**Board Approval – July 2005 Minewater Contingency Plan**

<b>Company:</b> Canadian Zinc Corporation (CZN)	
<b>Location:</b> Prairie Creek Mine	<b>Application:</b> MV2001L2-0003
<b>Date Prepared:</b> August 9, 2005	<b>Meeting Date:</b> August 24, 2005
<b>Subject:</b> Plan approval – Minewater Contingency Plan

**Comment Summary Table**  
**Prairie Creek Minewater Contingency Plan**

**RE: Minewater Contingency Plan, MV2001L2-0003**

Figure 2: Prairie Creek Mine Water Management Site Plan

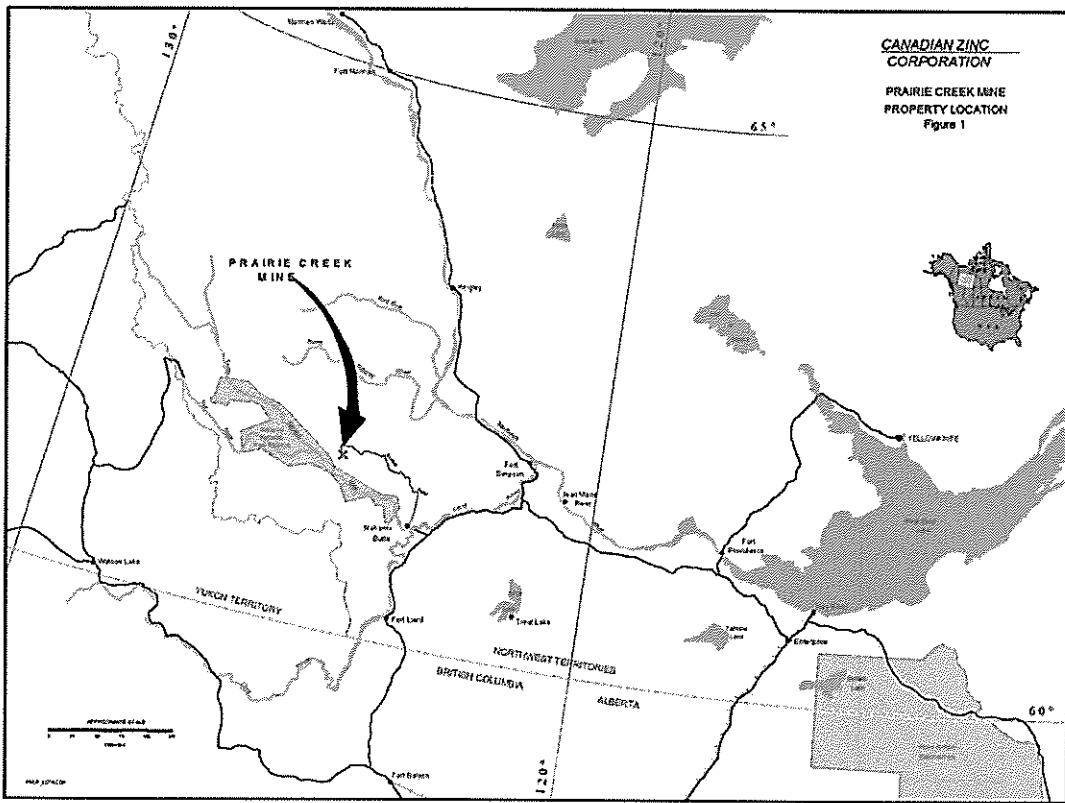
4. *Provide the locations, sampling frequencies and the parameters to be monitored for at all sampling locations. Board staff suggests that this information be summarized in a table and on a map.*

This information is also given in the Water License (under SNP). The sampling frequency and analytical parameter information will be given in table format, and sampling locations shown on a figure, in the revised MCP.

CZN will comply with the SNP monitoring requirements as specified in the Water License (under SNP). The sampling frequency and analytical parameter information is summarized in Table 3. Sampling locations are shown in Figure 5.

Figure 3: Prairie Creek Decline and Pilot Plant Water Balance

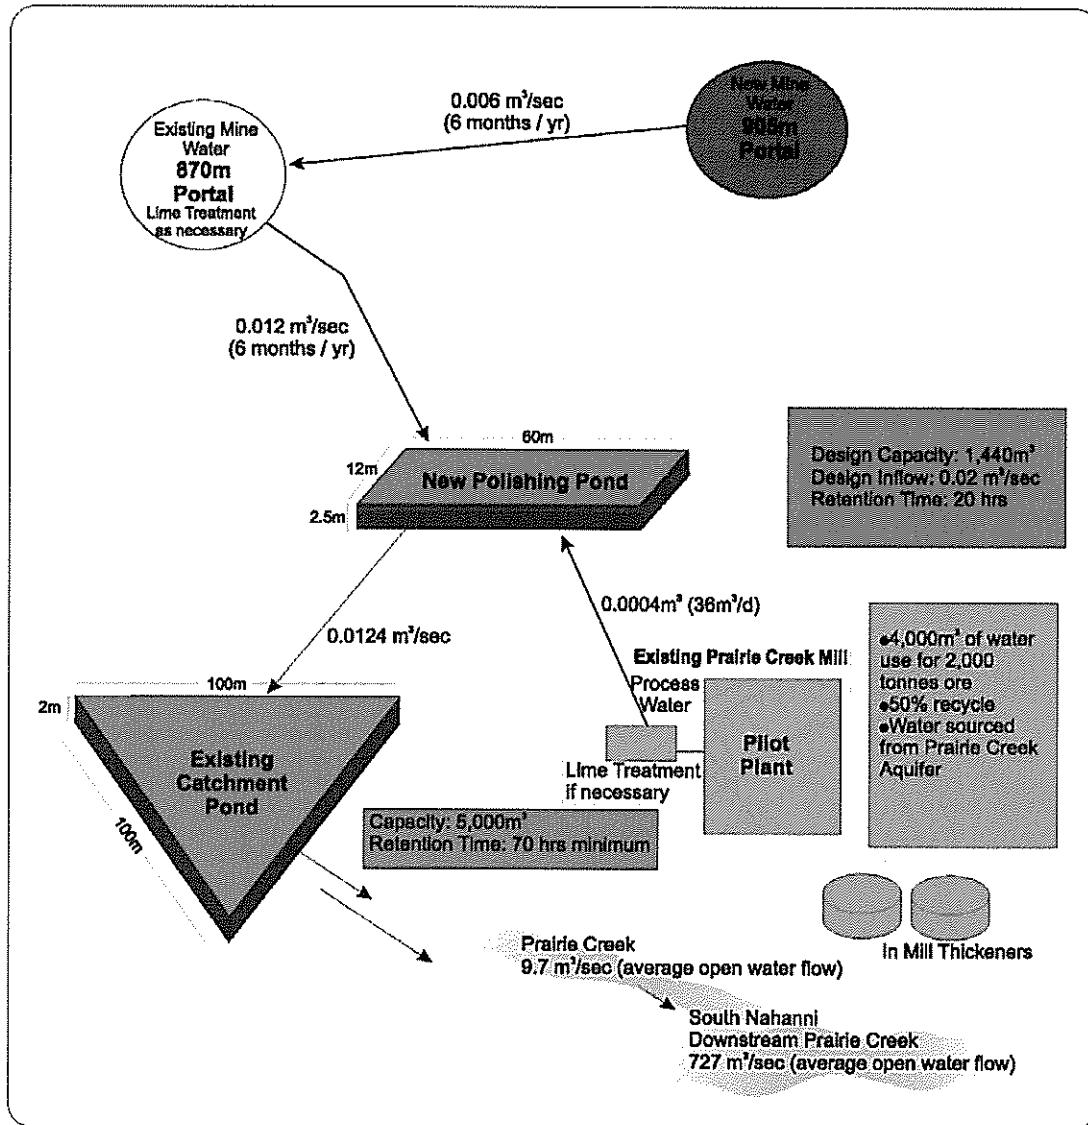
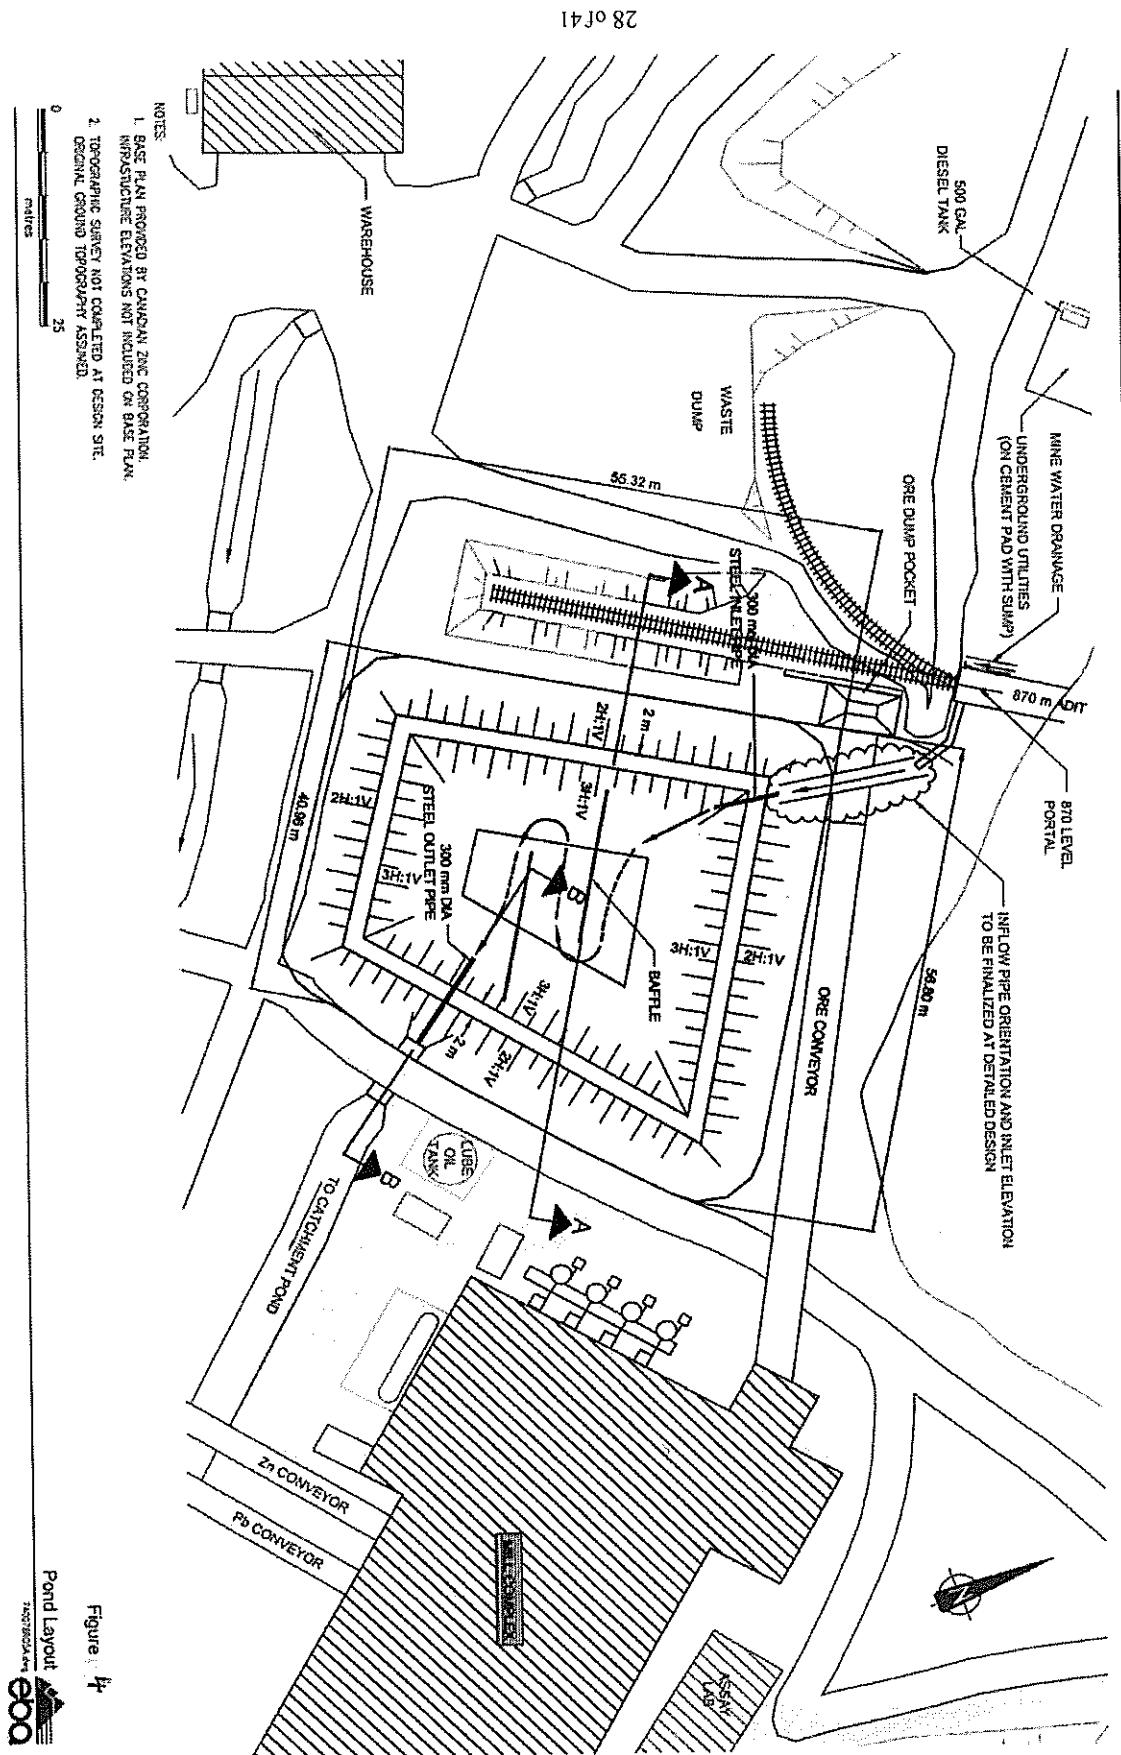
<p>parameters to be analyzed, frequency of the analysis, and the regulatory requirement for each parameter. One comment that refers to site-specific sampling states: "The quality of the minewater from the new 905m sump (SNP Station No. 3-2...) as well as minewater on the 870m level... (SNP Station No. 3-7), will be monitored at least monthly as required." These two stations, according the SNP outlined in Water Licence MV2001L2-003 must be sampled at least weekly.</p> <p><b><u>Comments related to the Polishing Pond</u></b></p> <p>4. Parks Canada recommends CZN incorporate all flow estimates recorded for the 870m portal discharge. Based on the July 2002 DIAND report (Historical Water Quality of the Prairie Creek Project Area), the design flow for water management planning should be 1.0 m<sup>3</sup>/min (16.7 L/sec) in order to incorporate any worst case scenario into the minewater contingency plan.</p> <p>The Polishing Pond dimensions, therefore, should be increased in size to account for a worst case scenario volume capacity. Even using the flow rates the company put forth as inputs to the Polishing Pond, there is discrepancy between the figures in the water balance and the actual capacity of the Polishing Pond:</p>

<p>Over a 24-hour period, this amounts to 1160 m<sup>3</sup>.</p> <p>The Polishing Pond only has a capacity of 1440 m<sup>3</sup>, based on a freeboard of 0.5 metres (12 m x 60 m x 2 m). If the freeboard was to be actually 1 metre, the capacity of the Polishing Pond was further reduced to 1080 m<sup>3</sup>. The inputs from the</p> <p>information will be given in table format, and sampling locations shown on a figure, in the revised MCP. Comment addressed. Please see Table 3 on page 24 of the MCP</p>	Excess process water:	0.00042 m <sup>3</sup> /sec	Mine water 870 decline:	0.006 m <sup>3</sup> /sec	Mine water 905 decline:	0.007 m <sup>3</sup> /sec	Total:	0.0134 m <sup>3</sup> /sec	<p>4. Please see the Discussion Section of the Staff Report.</p>
Excess process water:	0.00042 m <sup>3</sup> /sec									
Mine water 870 decline:	0.006 m <sup>3</sup> /sec									
Mine water 905 decline:	0.007 m <sup>3</sup> /sec									
Total:	0.0134 m <sup>3</sup> /sec

<p>processing activities and the declines would exceed the capacity of the Polishing Pond in less than 24 hours. This calculation did not include any contributions from rainfall events or more significantly, from the spring freshet.</p> <p>CZN states that there is sufficient area available to enlarge the pond if necessary to accommodate a larger flow. How can the pond be enlarged and properly lined after the fact if it is already filled with water? It seems it would be more appropriate if the pond was built to the appropriate size initially.</p>	<p>1. The Dehcho First Nations have serious concerns with the current water Licence MV2001L20003, as issued by the Board. These issues include water treatment contingencies. As the Dehcho First Nations concerns are being addressed outside the Board's regulatory process, we are not submitting comments on the Minewater Treatment Contingency Plan recently provided by CZN.</p>	<p>1. Comment provided to the Board.</p>
